**DRAFT RESPONSES TO THE U.S. ENVIRONMENTAL PROTECTION AGENCY COMMENTS
ON THE WASTE ACCEPTANCE CRITERIA ATTAINMENT PLAN FOR THE ON-SITE DISPOSAL
FACILITY**

**RESPONSES TO U.S. EPA COMMENTS
ON THE DRAFT
WASTE ACCEPTANCE CRITERIA ATTAINMENT PLAN
FOR THE ON-SITE DISPOSAL FACILITY
(AUGUST 1997)**

**FERNALD ENVIRONMENTAL MANAGEMENT PROJECT
FERNALD, OHIO**

Figure 4-9 - MATERIAL DESTINATION DECISIONS AND ORGANIZATIONAL HAND-OFF

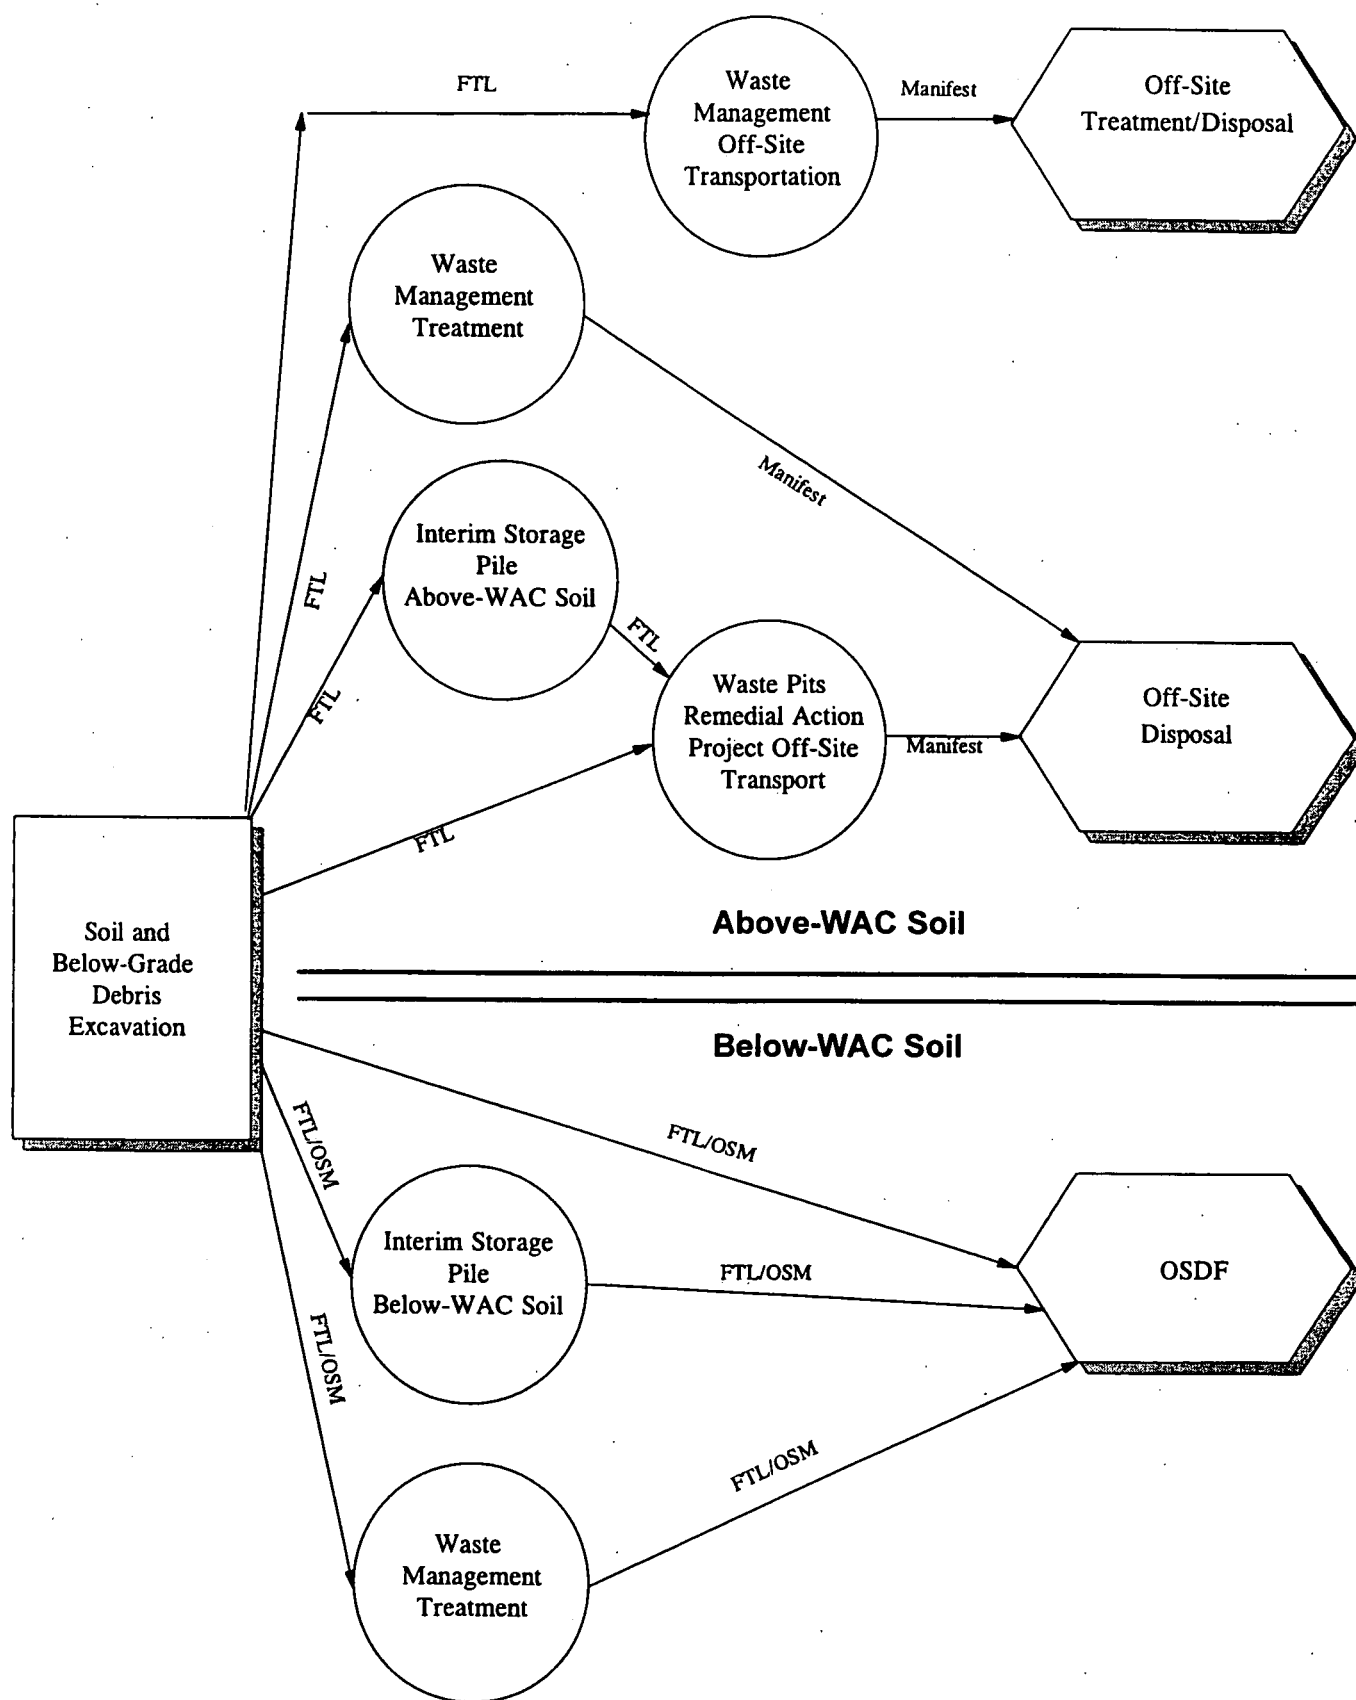
19. Commenting Organization: U.S. EPA
Section #: Figure 4-9
Original Specific Comment #: 16
- Page #: 4-31
- Commentor: Saric
Line #: NA
- Comment: The figure provides a flow chart for material destination decisions for above- and below-WAC soils. One of the options identified for above-WAC soil is "waste management treatment and disposal." The figure should be revised to label this option as "waste management treatment." In addition, Page 4-32, Line 13 refers to above-WAC soil that would not undergo treatment if it is not cost-effective. The figure should be revised to incorporate this option. Finally, Page 4-33, Line 8 states that untreated, below-WAC material may be transported off site for treatment and disposal. The figure should be revised to include this option.

- Response: The text on page 4-33, line 8 is referring to material that meets all WAC except that it contains RCRA characteristic waste; it will therefore be managed as above-WAC material. The option for "Waste Management Treatment and Disposal" has been revised to "Waste Management Treatment" and an option has been added for off-site disposal by Waste Management without on-site treatment.

- Action: The figure has been revised as stated in the response and is attached to this comment response document.
